PITT STREET SOUTH OSD - RESPONSE TO REQUEST FOR INFORMATION #2

This letter provides a response to the Request for Information (RFI) prepared by the Department of Planning, Industry, and Environment (DPIE) dated 26 November 2020. In accordance with the RFI, this letter provides supplementary information for the assessment of SSD 8876 and SSD 10376 relating to the Pitt Street South Over Station Development.

Figure 1 Comparison of GRC column locations and depth

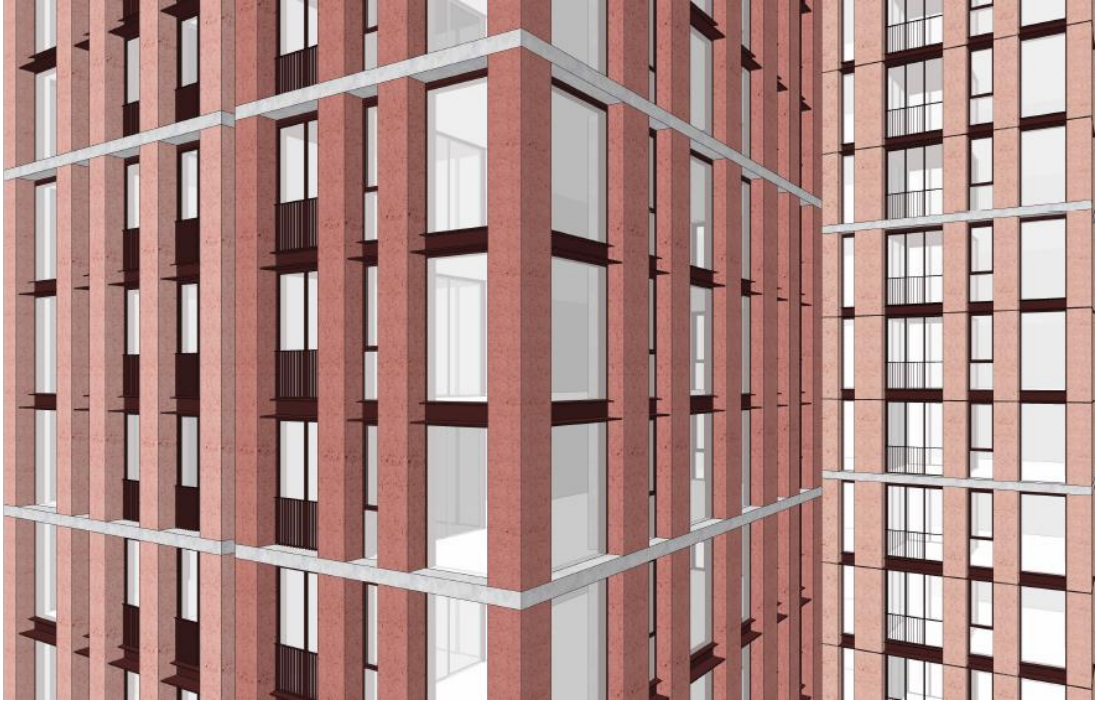
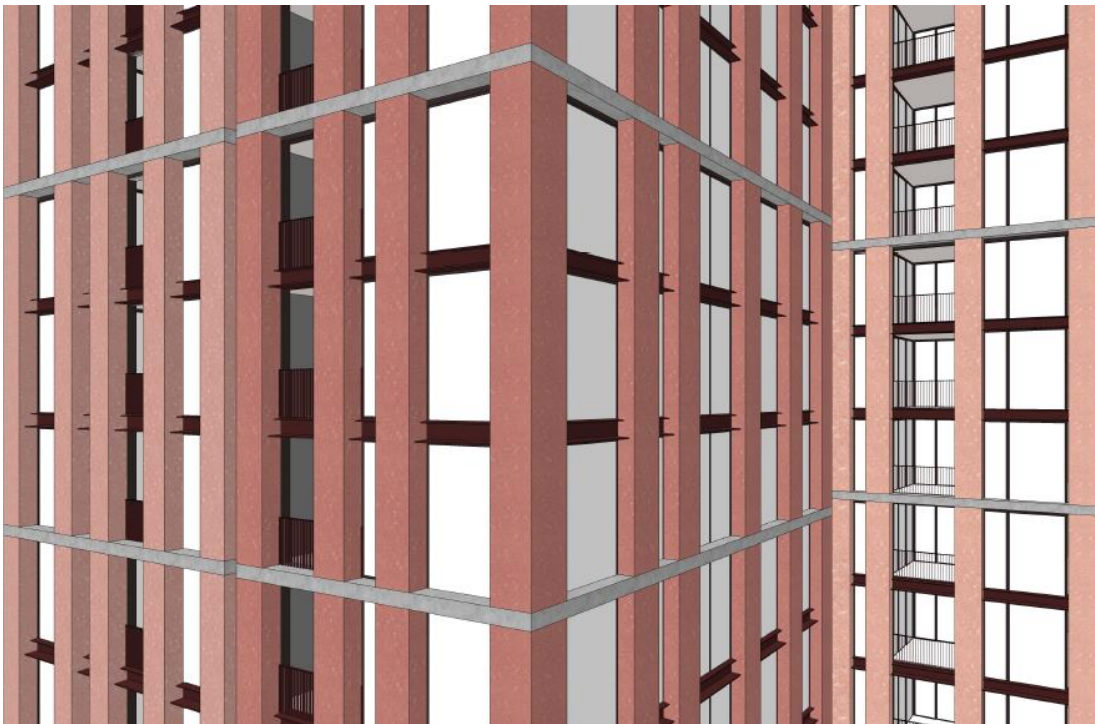
The DPIE have requested an additional description and illustration of recent amendments to the façade in relation to the location of the GRC 'columns' proposed for the over station development. We clarify that the GRC are not 'columns' but elements on the external face of the building. They do not provide structural benefits to the building.

However following a review of 1:1 printed detailing of the Response to Submissions proposed GRC elements, the Design Review Panel (DRP) provided feedback that they did not support the reduction in depth of the GRC on the northern, eastern and western façades as the flattening of these elements was perceived to change the architectural expression of depth and relief in the façade. Notwithstanding, the panel did support a change in the width of the GRC elements from 800mm to 900mm as proposed in the Response to Submissions package.

The DRP also noted that there was a reduction in the number of GRC elements proposed on each façade, and the reduction in solid elements on the façade impacted the achievement of design excellence. Following receipt of this feedback, the design team undertook additional architectural studies to increase the number of GRC elements on the façade and re-instate the original depth of the

elements, with the exception of the southern façade, and presented these changes to the DRP. This change is reflected in the revised Architectural Plans at **Attachment A**.

As outlined in the Design Integrity Report submitted with the response to RFI dated 12 November 2020, the DRP supported the reduction of seven elements compared to the original State Significant Development Application (**SSDA**) scheme. The DRP also recommended specific changes to the location of the 'columns' along the western façade of the north-western corner, and the eastern face of the north-eastern corner to achieve a slightly more varied and less regular spacing which is more consistent with the SSDA design. As outlined in the Design Integrity Report, the DRP have now provided their support for the current GRC elements proposed on the building façades.

Figure 1 provides a visual comparison of the location and depth of the GRC elements included in the original SSDA and the current proposed when viewed from the north western façade. Further visualisations are provided in the Supplementary Architectural Design Report issued to DPIE on 12 November and attached again at **Attachment B** for reference.

Figure 2 Comparison of projections from the building envelope

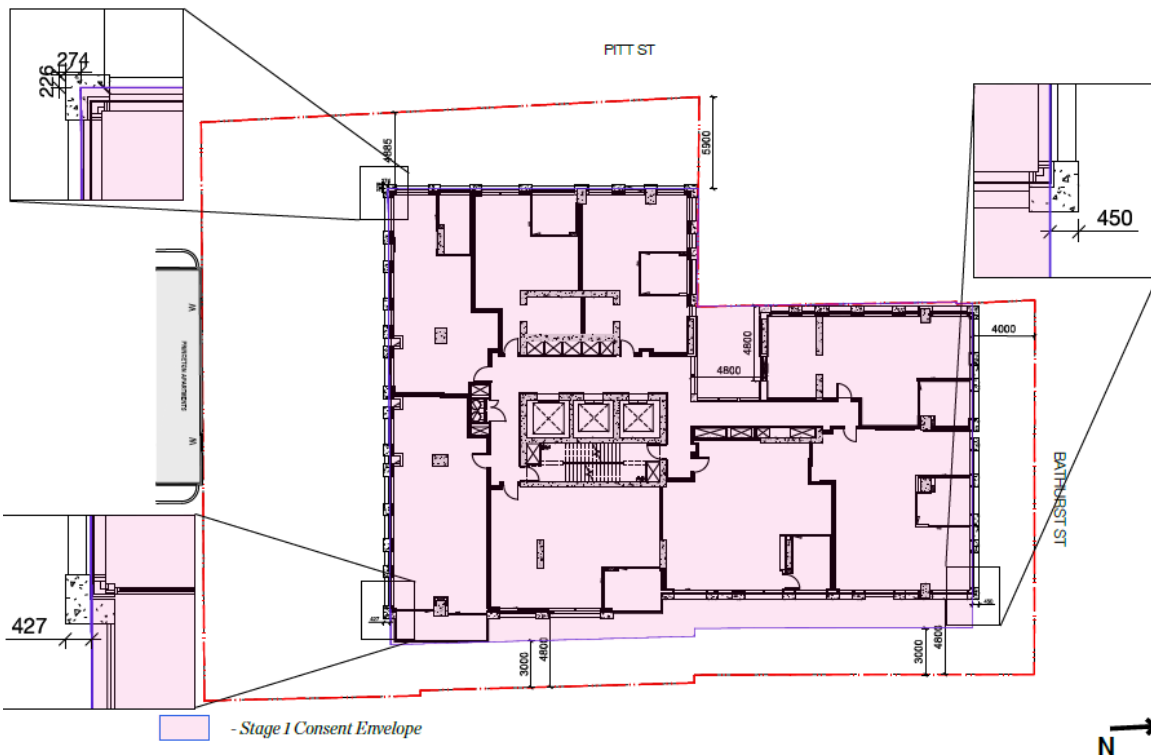
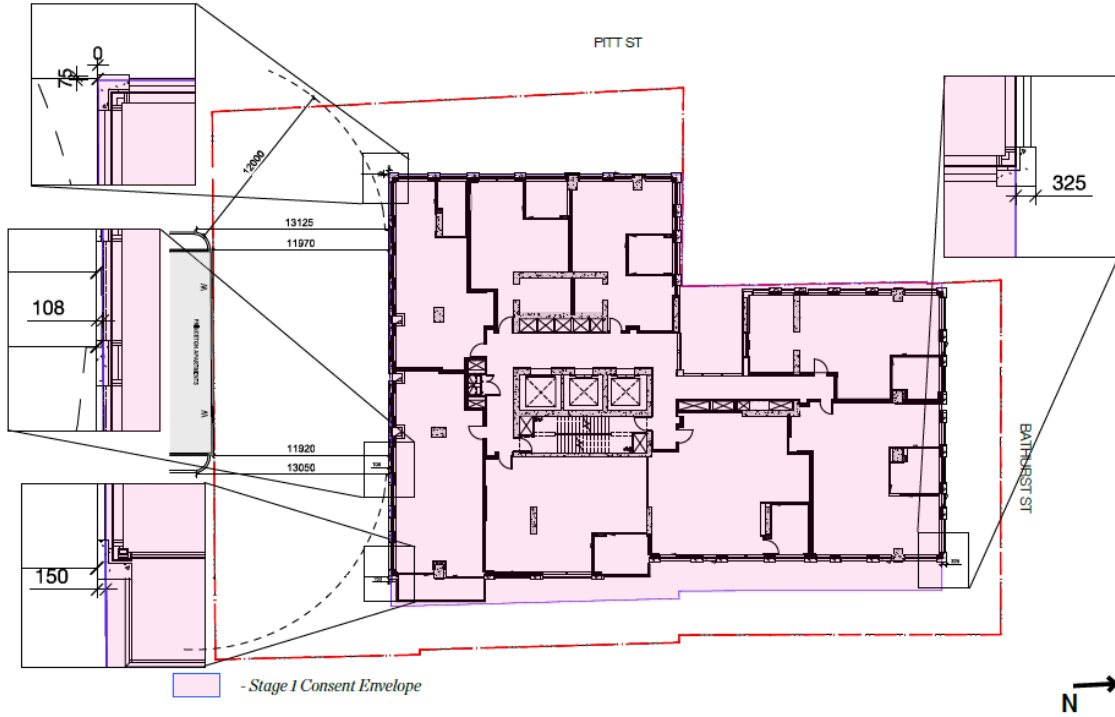
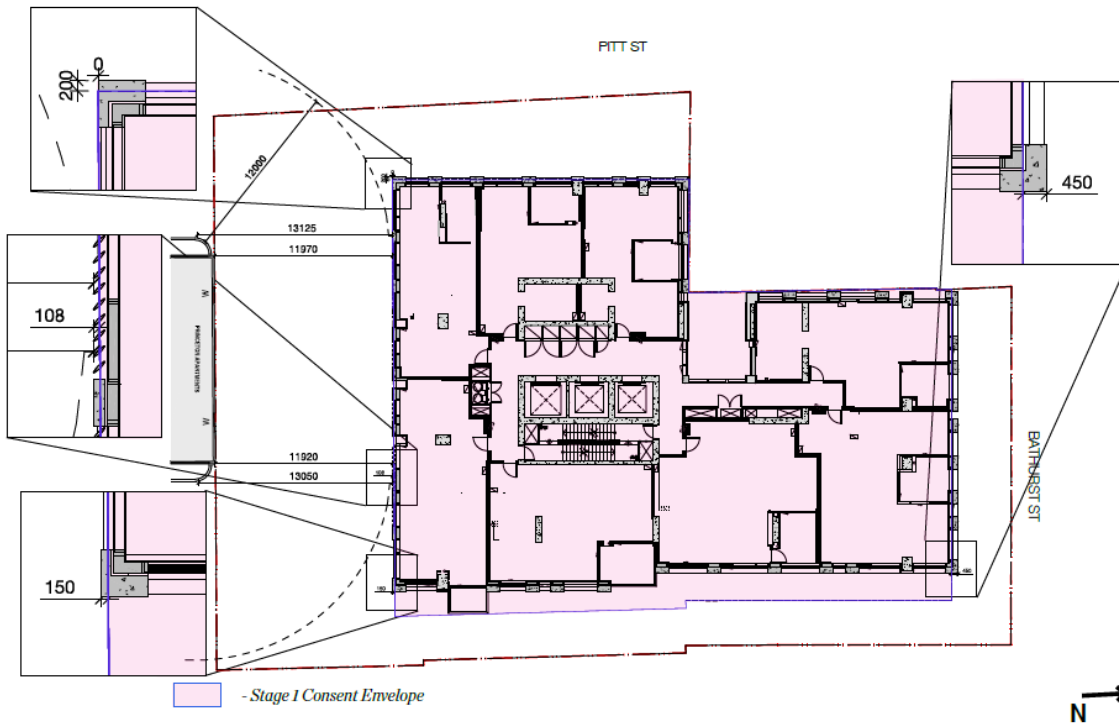
The DPIE have also requested detail on whether the proposed changes to the GRC configuration have impacted any analysis submitted with the Response to Submissions, in particular the Supplementary Solar Analysis Statement provided by Wash Analysis, dated 10 November 2020, and the projections/encroachment on the approved building envelopes and respective site boundaries. These items are addressed in the following sub-sections.

Bates Smart Architects has prepared a diagram at Figure 2 and attached at **Attachment D** which shows the extent of projections proposed beyond the approved concept envelope. As outlined in this figure, the depth of the projections from the approved concept envelope remains reduced from the original SSDA on the southern and western elevations. No building extent has ever been proposed to project beyond the site boundary.

In summary the maximum projections from the approved concept envelope proposed in the original SSDA and now within the Architectural Plans at **Attachment D** are provided in Table 2.
